Project Reference #11516

RE: Additional Site Investigation Work Plan  
Former Try-Chem Corp, 1333 West Pierce Street, Milwaukee, WI 53204  
**BRRTS #02-41-409441**

Subject: Request for Additional Information  
Try-Chem Corp., 1333 W. Pierce St., Milwaukee, WI 53204  
DNR BRRTS # 02-41-409441, FID # 241078530

**PROPOSED BOREHOLE LOCATION  
MAP WITH PREVIOUS BORINGS**  
1333 WEST PIERCE STREET  
MILWAUKEE, WISCONSIN

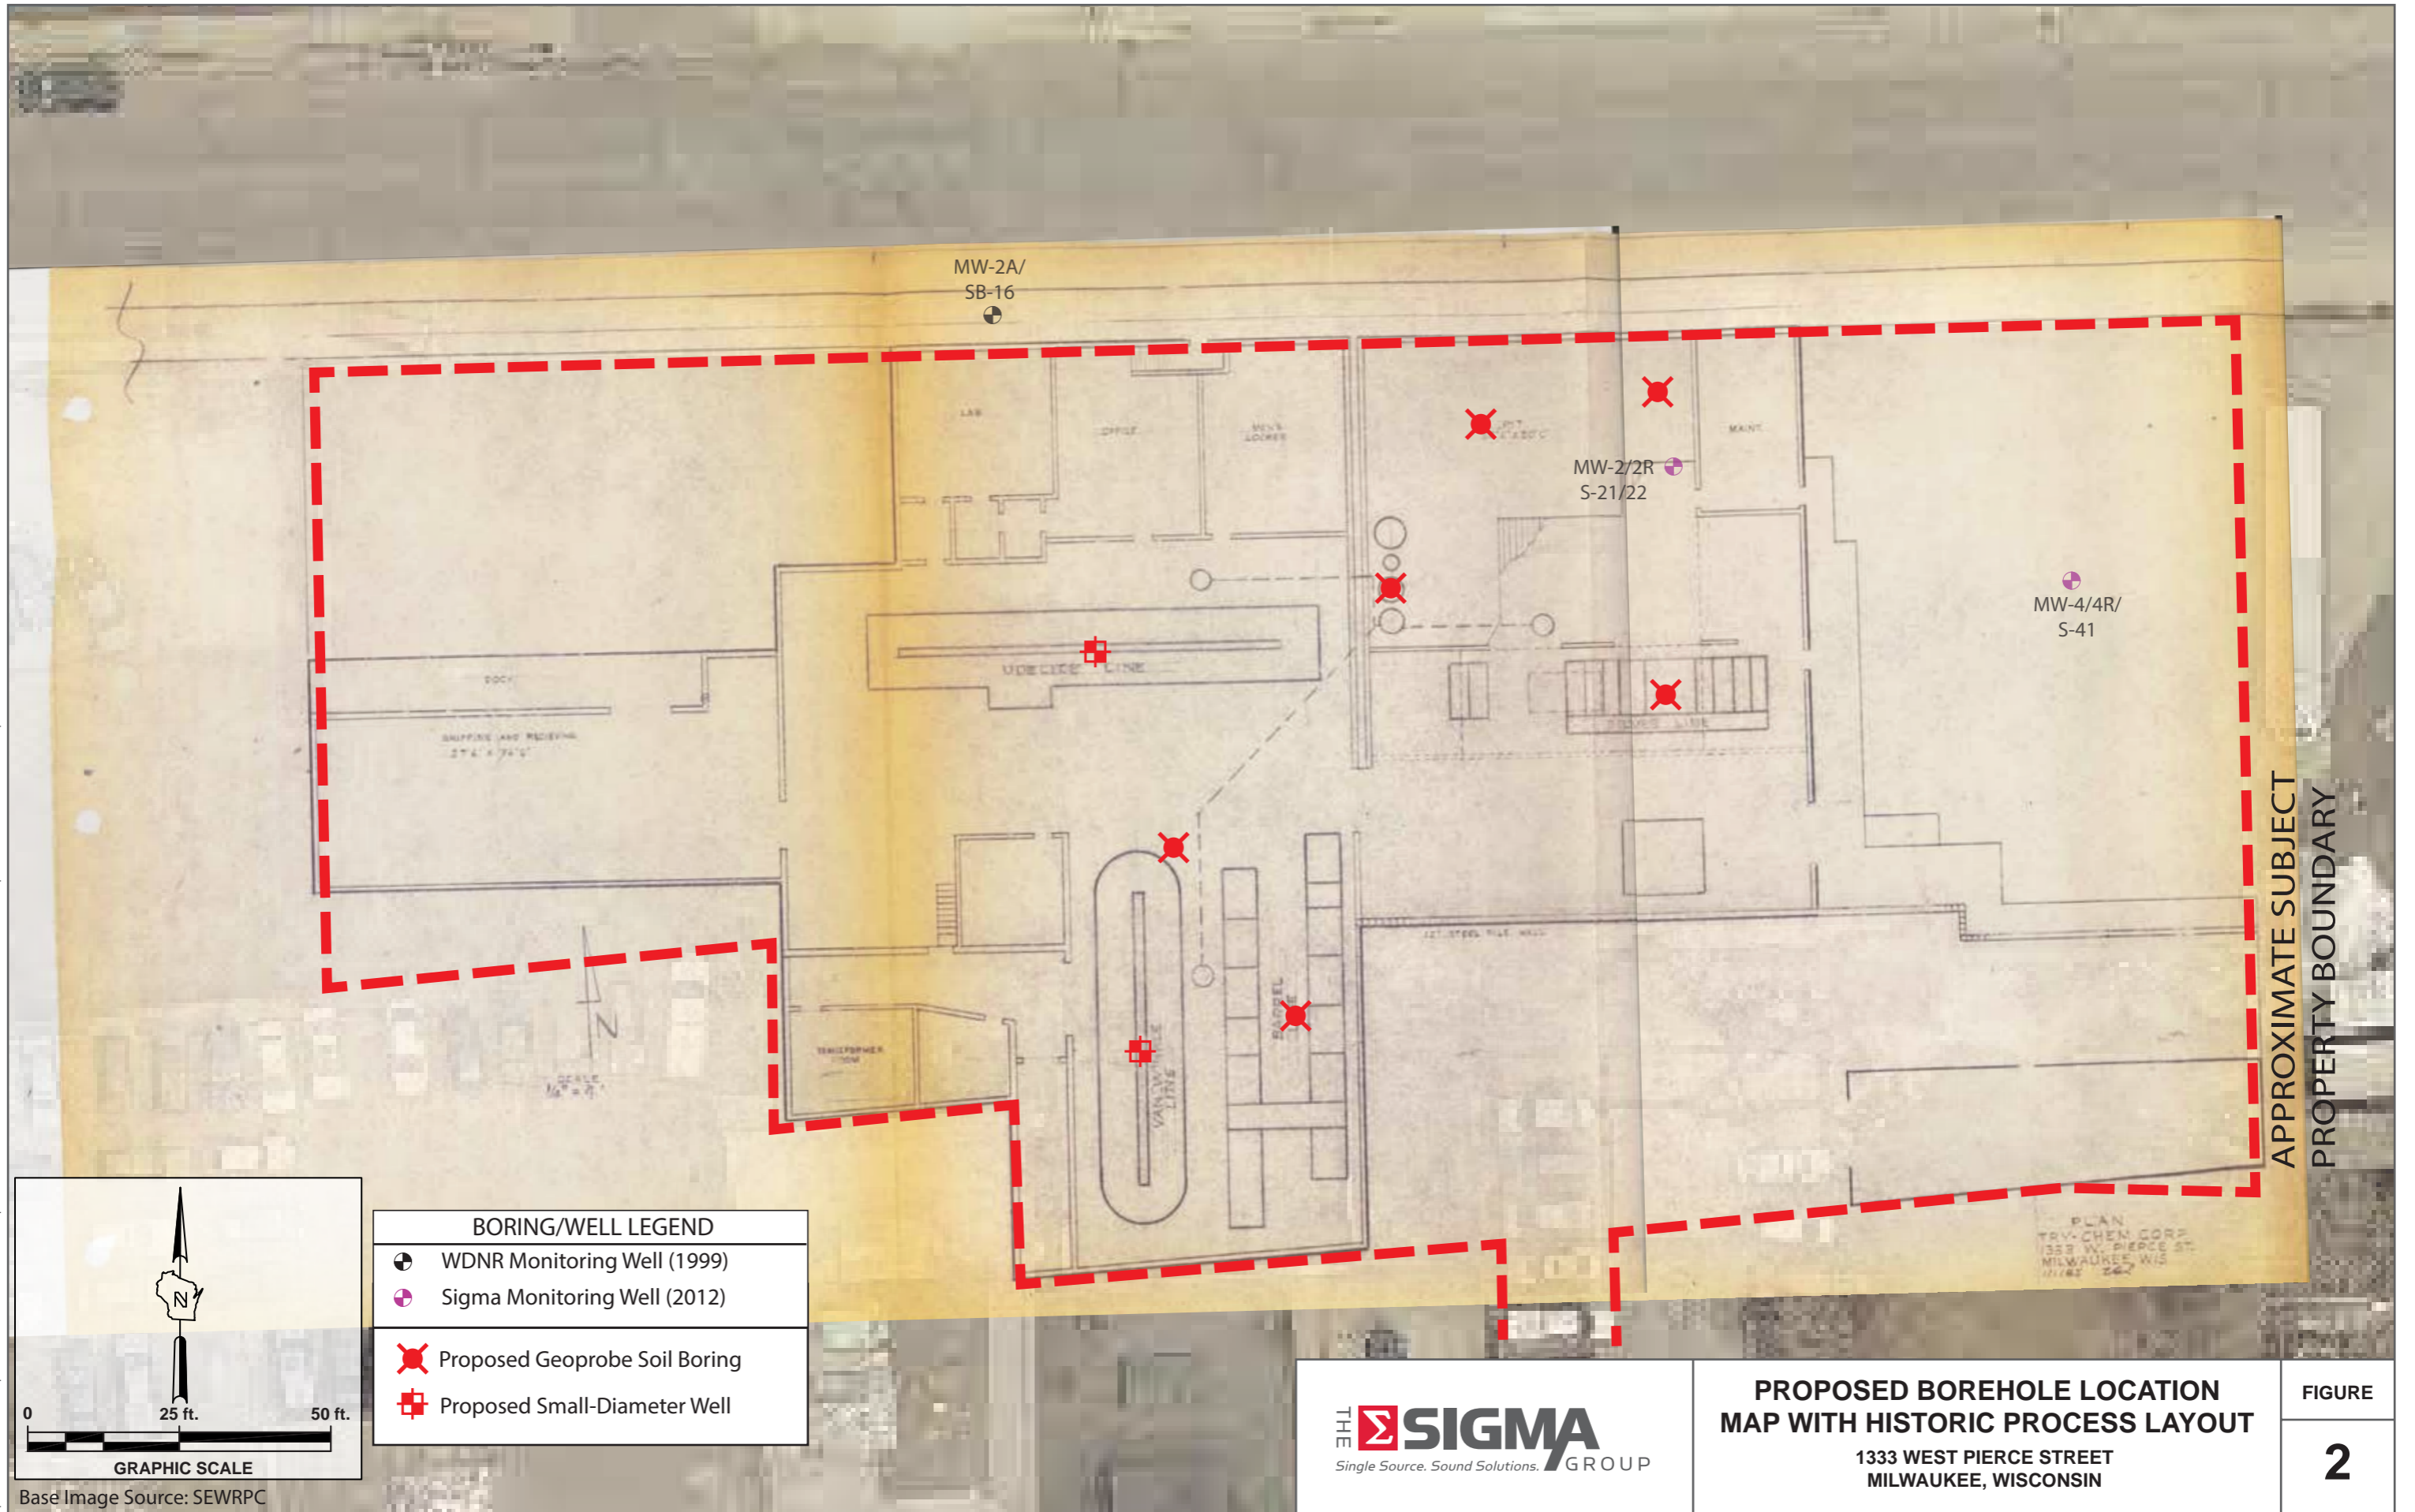
In consideration of the site limitations, Sigma proposes installing two small diameter pre-constructed or prepack monitoring wells using Geoprobe® direct push drilling methods. To install the prepack monitoring well, Sigma will drill a 2.25- or 3-inch outer diameter soil boring to an appropriate depth below the ground surface. The prepack monitoring well assembly will then be lowered into the probe rod string with threaded riser pipe. Once the assembly is lowered to the bottom of the probe string, the probe rods will be retracted to directly above the well screen (10 feet of 0.010-inch slotted PVC pipe). An additional sand barrier installed directly above the well screen will prevent the bentonite seal from entering the screen. Factors that limit the use of a typical 2-inch diameter monitoring well include additional project costs and limiting damage to the site wide surface cap. The proposed monitoring well locations are shown on **Figure 1**.
